SN. 09/121,702

For: HEATING OR AIR CONDITIONING

SYSTEM FOR A MOTOR VEHICLE

PROPOSED DRAWING AMENDMENT FOR EXAMINER'S APPROVAL

EXHIBIT A

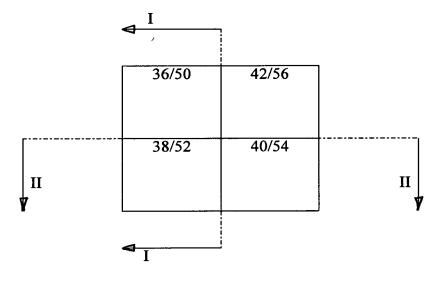
Claims 1-10 were rejected under 35 U.S.C. § 112, first paragraph, because the original specification does not enable one skilled in the art to use and/or make the claimed invention. Applicants again traverse this rejection for the same reasons set forth in the last reply. Applicants submit a schematic illustration (Exhibit A) of the four mixing chambers 50, 52, 54, and 56 and their respective warm-air control elements 36, 38, 40, and 42. The direction of air flow is into the page.

Fig. 1 illustrates the left half (36/50, 38/52) of the housing 12, whereas Fig. 2 illustrates the lower half (38/52, 40/54) of the housing. The examiner is correct that the complete upper half or the complete right half of the housing containing elements 42/56 is not shown. The examiner required applicants to illustrate elements 42/56. In this respect, revised Fig. 3 was submitted, completely illustrating elements 36/50, 38/52, 40/54, and 42/56.
